Access Compliance Report

Public Rights-of-Way

Intersection ID: 53096	Main Street: ROBERT_IRWIN_DR	Cross Street: DIXIE_RIVER_RD	Location:	N
ADA ID: 7AFD3729ECF1	Ramp Type: PerpDiag	Initial Pass/Fail: Fail	Overall Compliance: No	Severity Score: 10

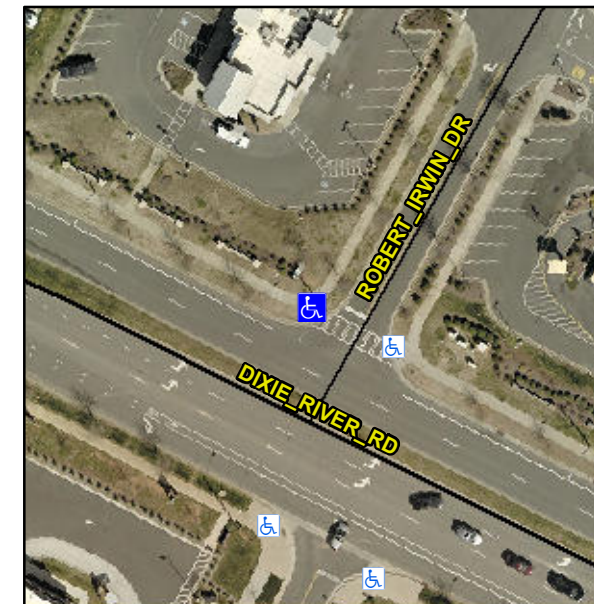
Not Found, R304.5.1, R304.5.3

Compliance	Description	Data	Compliance	Description	Data
N/A	Ramp Length (in)	96.0	Yes	Ramp Slope (%)	7.8
No	Ramp Width (in)	46.0	No	Ramp XSlope (%)	3.9
N/A	Flare Type LT	N/A	N/A	Flare Type RT	N/A
N/A	Flare Slope LT (%)	N/A	N/A	Flare Slope RT (%)	N/A
N/A	Flare Traversable LT?	N/A	N/A	Flare Traversable RT?	N/A
N/A	Landing Length (in)	N/A	N/A	DWS Provided?	N/A
N/A	Landing Width (in)	N/A	N/A	DWS Contrast?	N/A
N/A	Landing Slope (%)	N/A	N/A	DWS Length (in)	N/A
N/A	Landing X Slope (%)	N/A	N/A	DWS Full Width?	N/A
N/A	Landing Curb? (Y/N)	N/A	N/A	DWS Offset (in)	N/A
N/A	Shared Landing?	N/A			
N/A	Gutter Ponding?	N/A	N/A	Gutter Slope (%)	N/A
N/A	Gutter Lip Ht (in)	N/A	N/A	Gutter X Slope (%)	N/A
N/A	Painted X Walk1?	No	N/A	Painted X Walk2?	Yes
	X Walk 1 Direction	To SE		X Walk 2 Direction	To SW
N/A	X Walk 1 Width (in)	N/A	N/A	X Walk 2 Width (in)	112.0
	X Walk 1 Slope (%)	3.5		X Walk 2 Slope (%)	2.5
	X Walk 1 X Slope (%)	0.7		X Walk 2 X Slope (%)	2.6

Remove & Replace Curb Ramp With Two New Directional Ramps or Equivalent.
